CHRIS ROBIN 20 FEDERAL 6

OXY USA WTP LIMITED PARTNERSHIP respectfully request permission to make a change to the cementing plans on the original APD. Please see the attached documentation for your review. If you have any questions or need further information, please feel free to contact us at any time.

OXY USA Inc
Chris Robin 20 Federal 6
Sundry Information

BOP Diagram

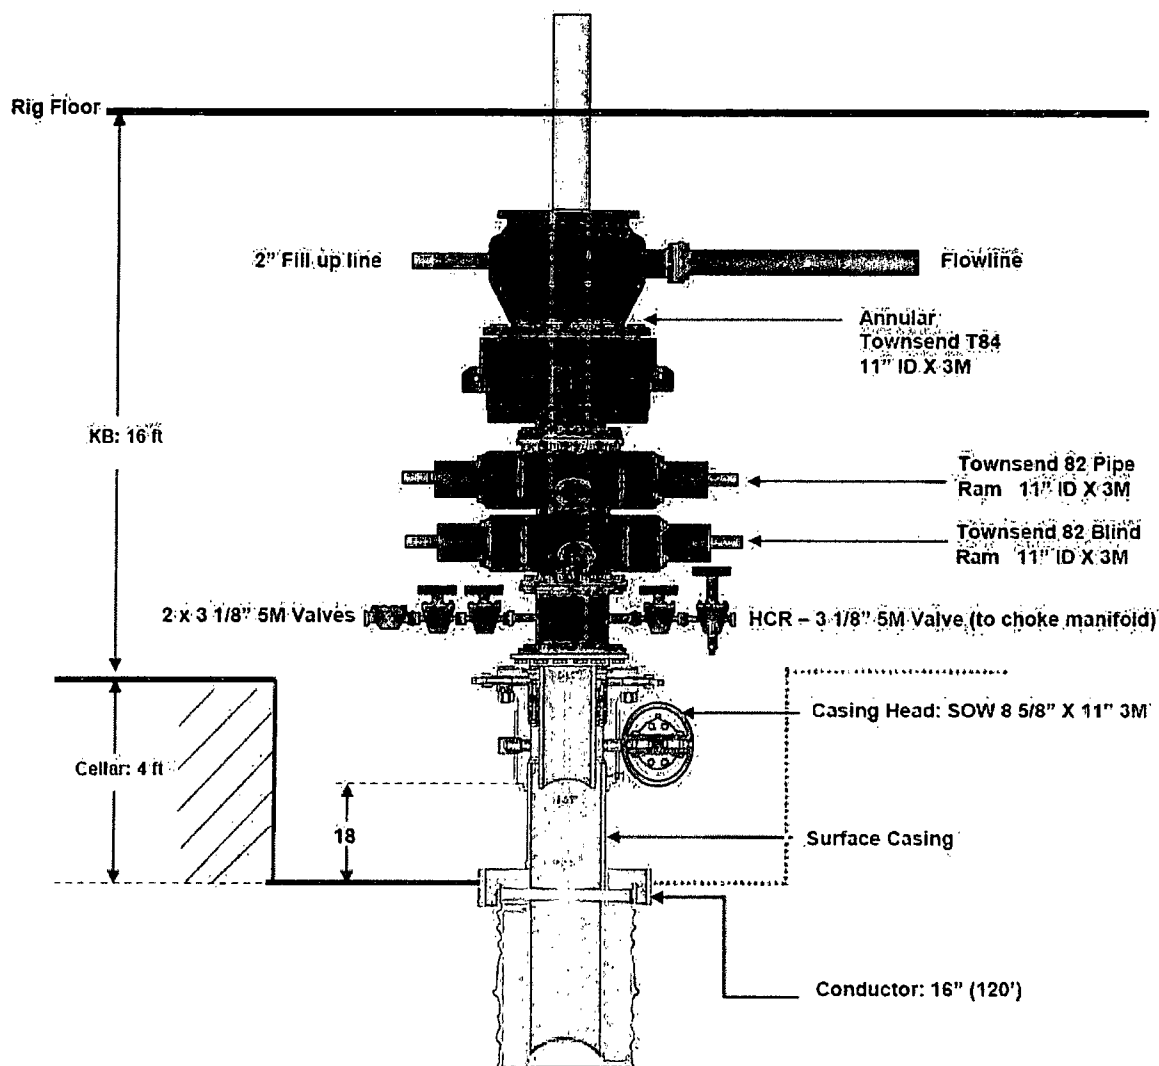
- a. Based on historic wells drilled in this area, the surface and production cement volumes have been adjusted. This will allow us to cut down on the excess cement having to be hauled off and exposed of.
- b. We will only run the 100 sks of lead thixotropic cement if losses occur while drilling the surface section.
- c. If a caliper log is run, cement volumes will be adjusted to caliper volume + 35% excess for the production hole.
- d. The corrected choke manifold and bop schematic can be found below. Oxy requests a variance to use the corrected choke manifold and bop.
